# Conceptual Review Agenda

Schedule for 07/27/15 to 07/27/15

# Red Cedar Light Industrial

**Re:** Red Cedar - Light Industrial

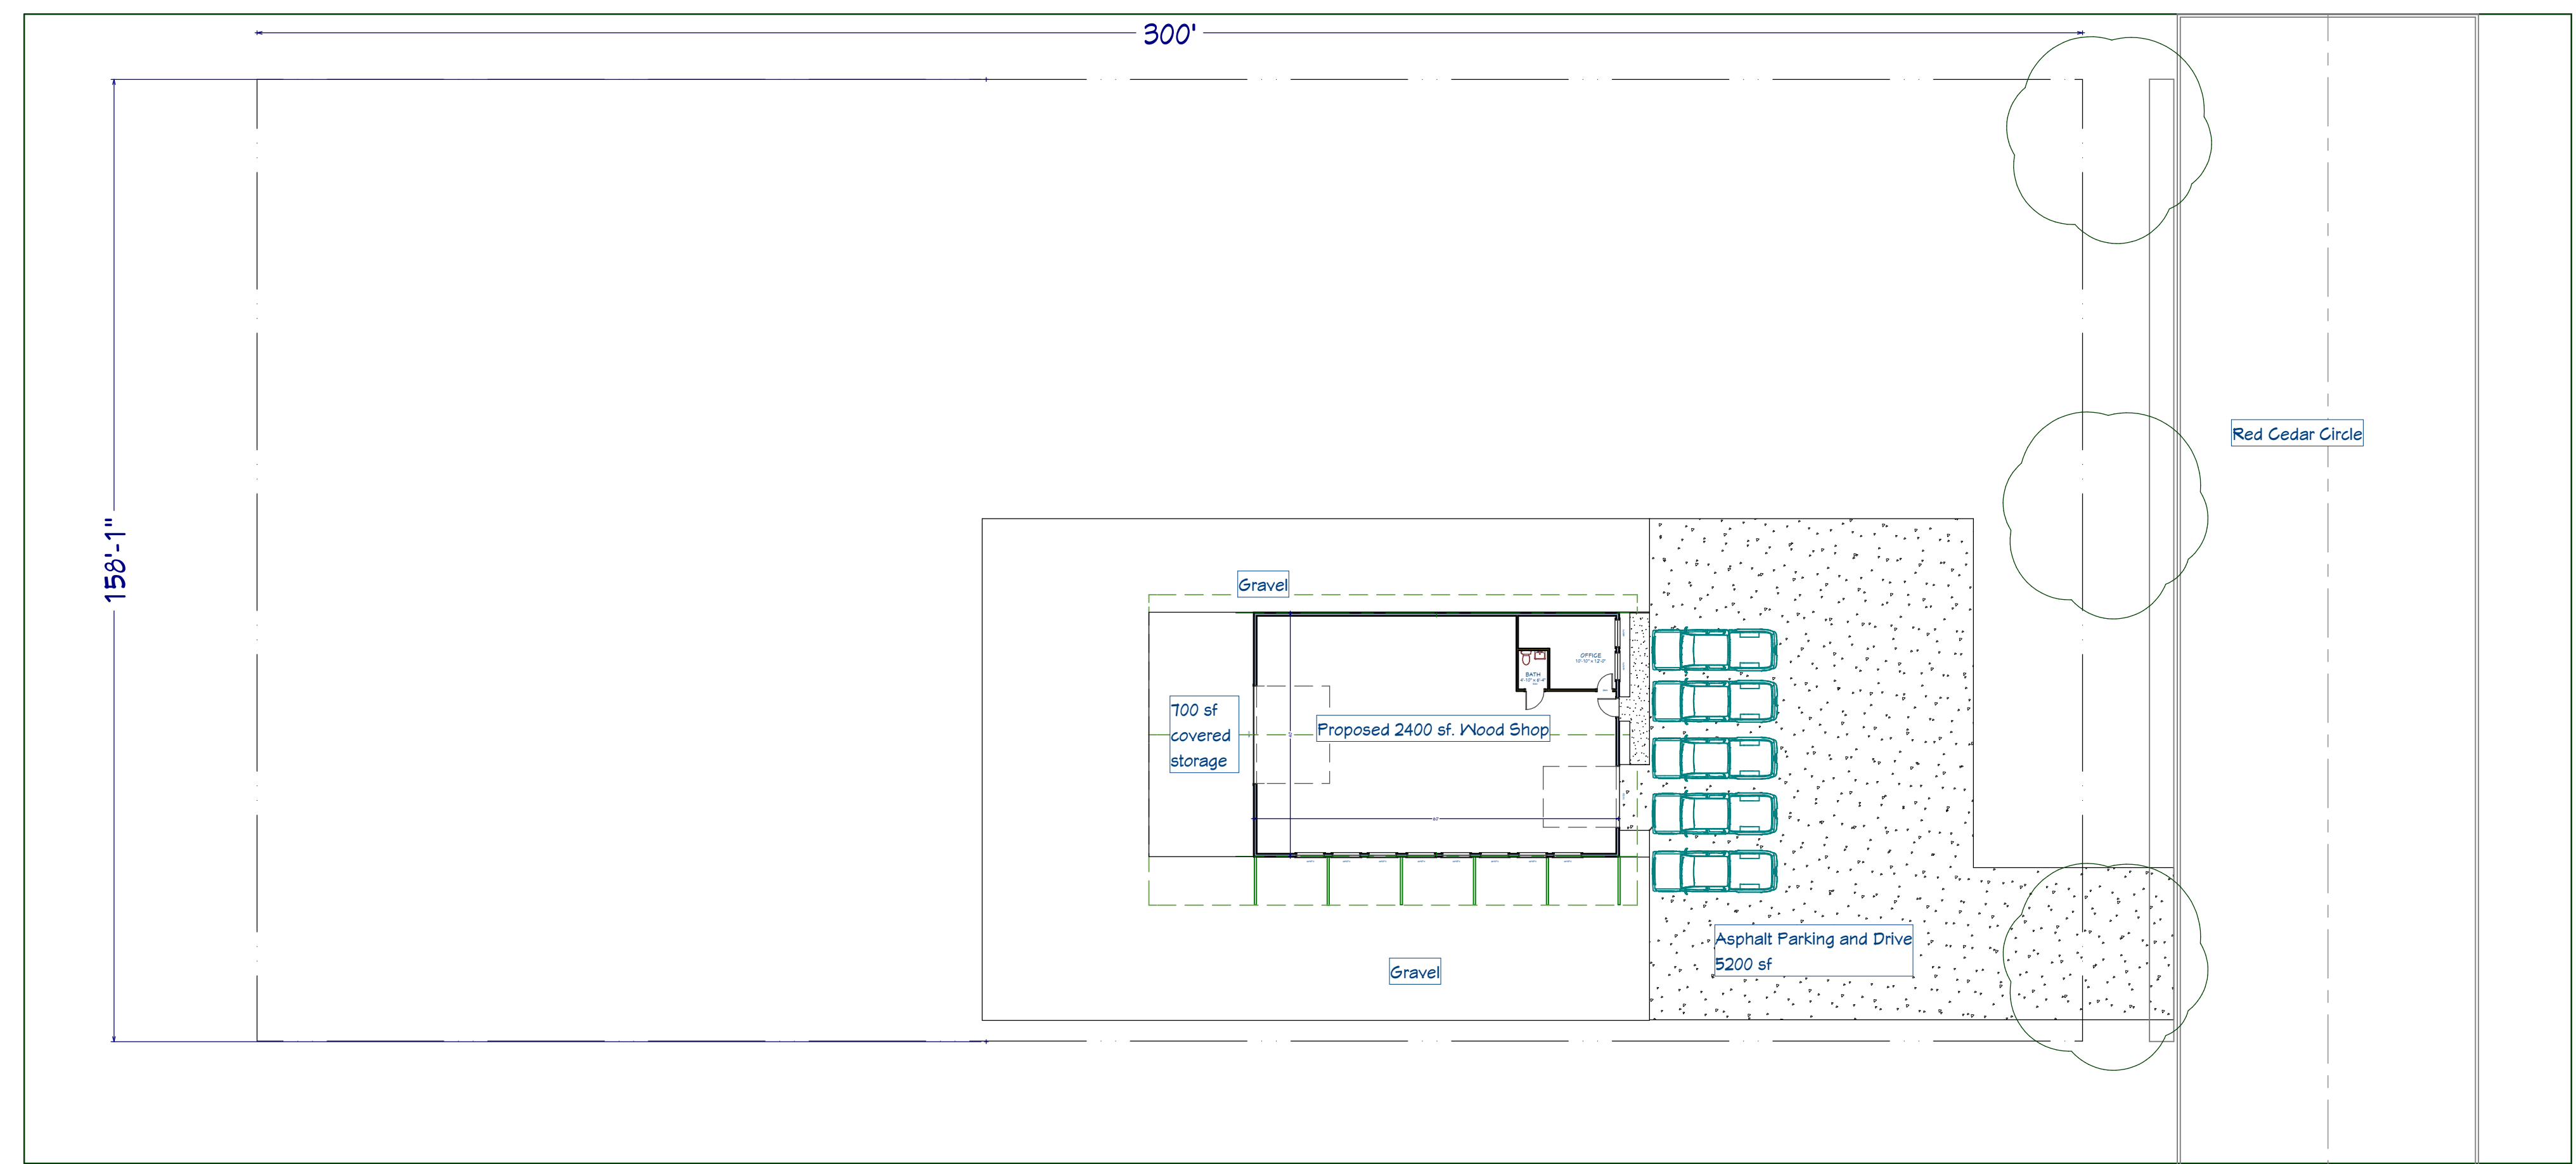
1. As with newer developments in this area and per code the building should be placed forward to within 15' of the front property line with parking/driveways to the side and rear of the building.

2. A 15' landscaping strip is from the front property line adjoining the parking lot and a 5' landscaping strip from the side and rear property lines adjoining the parking lot is required.

3. The lot areas outside the parking lot and building cannot be used for outdoor storage or parking. A fence or other decorative barrier must be installed preventing vehicle access into this area. If an outdoor storage area is proposed please show along with details of the screened area. Screening walls must match the building in color/texture/material.

4. Foundation plantings around building are required.
5. Parking requirements (including bicycle) can be found in LUC 3.2.2
6. No trash enclosure is shown. Enclosures must meet LUC 3.2.5 which includes a separate door for staff to access without opening main doors. Walls must match the building in color/texture/material and metal doors are required.

7. The gravel area may not be used for general parking. Only those vehicles used in the operations can be located there.

1. Please add a table that describes the parking required by your project and the parking you will be providing.
2. Please add a table that outlines the size of the lot, the size of the building, and the amount of impervious area you will be adding based on your proposal.

3. You will need to provide landscaping on the perimeter of your parking area per Land Use Code section 3.2.1(E)(4). Your parking area needs to be screened from abutting uses and the street. The screening will need to cover 70% of your frontage of the parking lot on Red Cedar Circle.

4. You will also need to landscape the interior of your parking area per Land Use Code section 3.2.1(E)(5). 6% of the interior of your parking area will need to be landscaped. This can be achieved easily by using landscaped islands.

5. You will need to provide 4 bike parking spaces per Land Use Code section 3.2.2(C)(4). You can provide these spaces via a fixed rack.
6. Please provide a connecting walkway per Land Use Code section 3.2.2(C)(5). The walkway needs to connect your front entrance to the sidewalk. The connecting walkway should not just follow the outline of the parking lot and should avoid crossing drive aisles.

8. You will need to provide one handicap accessible parking space per Land Use Code section 3.2.2(K)(5).
9. Please show where the parking spaces will be striped in. Also make sure that these parking spaces meet the dimensional requirements outlined in Land Use Code section 3.2.2(L).

10. There's no trash and recycling enclosure shown. Please add a trash and recycling enclosure per Land Use Code section 3.2.5. The enclosure should be screened from view, built on a concrete pad, and allow walk-in access without opening the main service gates.

11. Will the gravel yard be fenced off? If so, the fence must meet the standards outlined in section 3.8.11 of the Land Use Code. The fence will be limited to 4 feet in height if between the building and front property line and if the fence is located in a side yard setback area. The maximum height in the rear yard is 6 feet. Chainlink fences are prohibited.

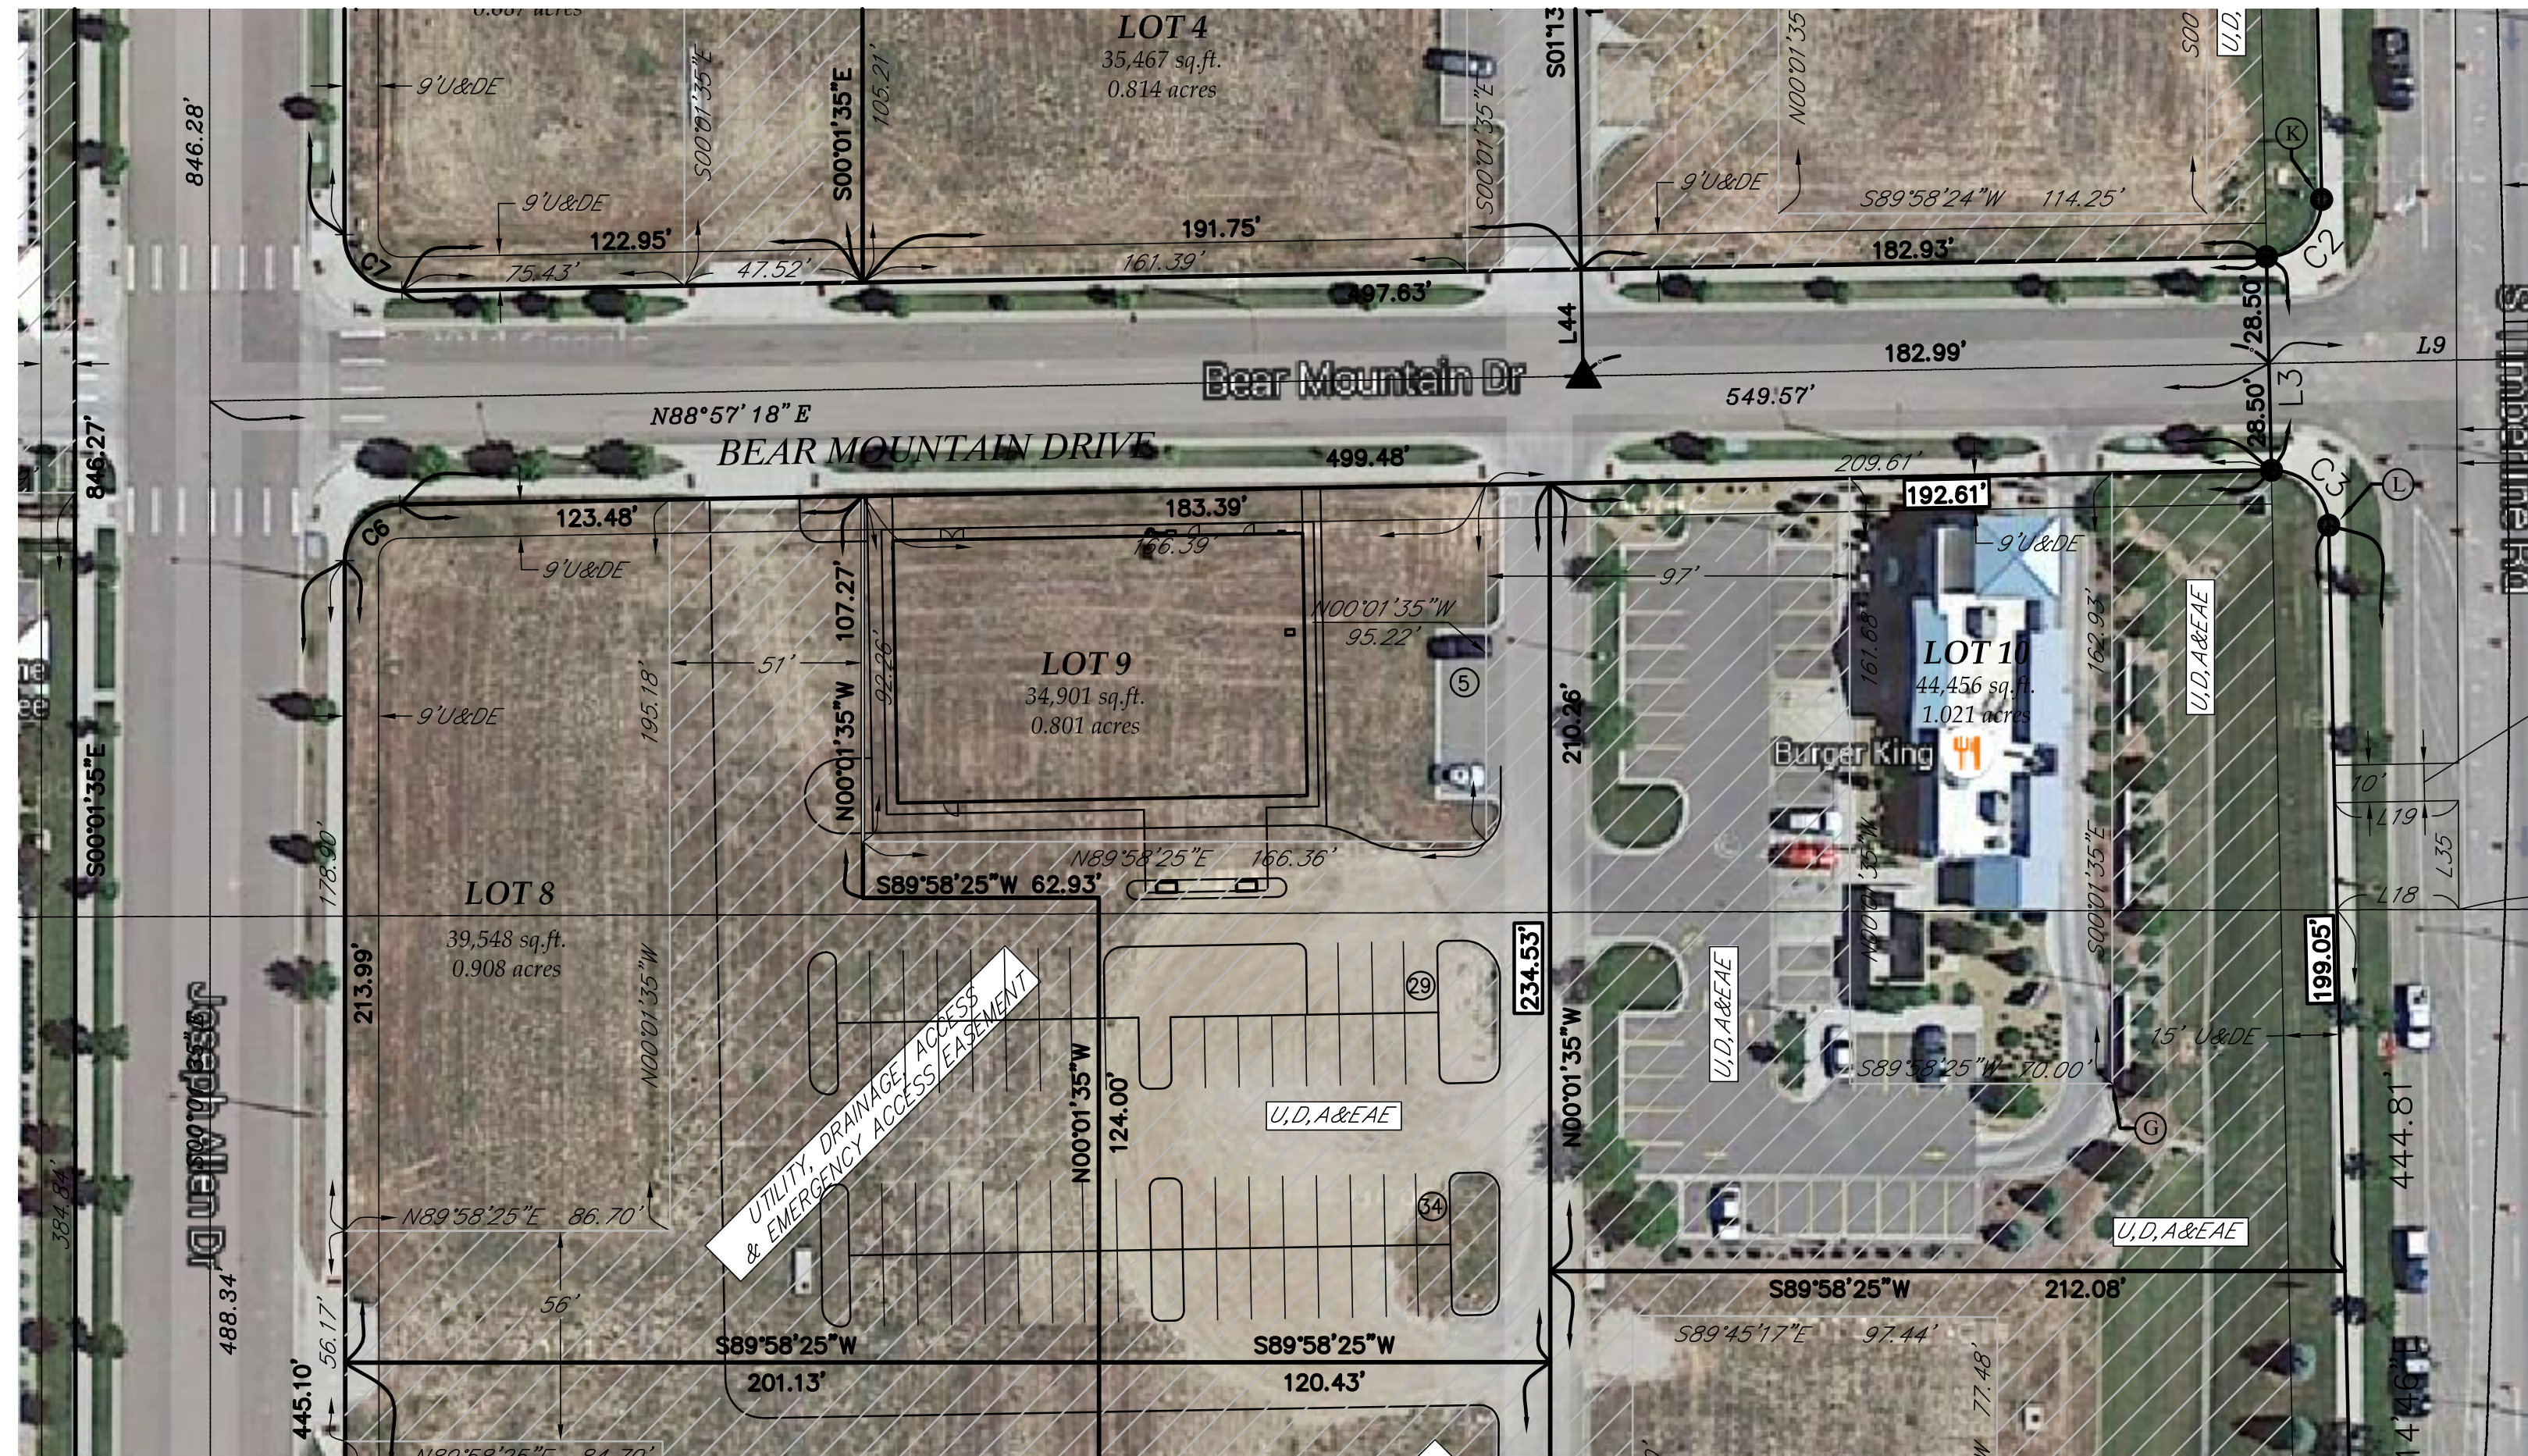
6. This project is responsible for dedicating any right-of-way and easements that are necessary for this project. This projects building looks to be larger than the building that was planned on this site. If so there are existing easement that will need to be vacated in order to approve

7. This project looks like it may be impacting the approved site layout beyond the boundaries of Lot 9. The project will either need to show how what is planned ties into what is approved on lot 8 and the lots to the south or those lot(s) will also need to be included in the application to show the changes to the site plan, grading drainage, and access.

10. LCUASS parking setbacks (Figure 19-6) apply and will need to be followed depending on parking design. Parking layout as was originally proposed met this requirement.

11. It may just be that this is a very conceptual level of drawing, but as currently shown we seem to have lost the pedestrian connections (E-W and N-S) that were a part of the original approved plan. How do you plan on incorporating these back in?

1. Sidewalk connection between uses within the center are required. Please show on the plans the surrounding context with the most recent plans from Ascent Studio. The plans must clearly show how the project is integrating with the surrounding plans.

2. Also show the planned commercial building to the north within the same block. The project must show context linework demonstrating how this building is incorporated, or how it is being changed. Also show how the parking works within the block -- the overall plans for the center state that parking will be shared. If this is no longer desired, the project must provide a table with the plans that shows how the parking for the uses is allocated to each use and how the parking requirements are being met.
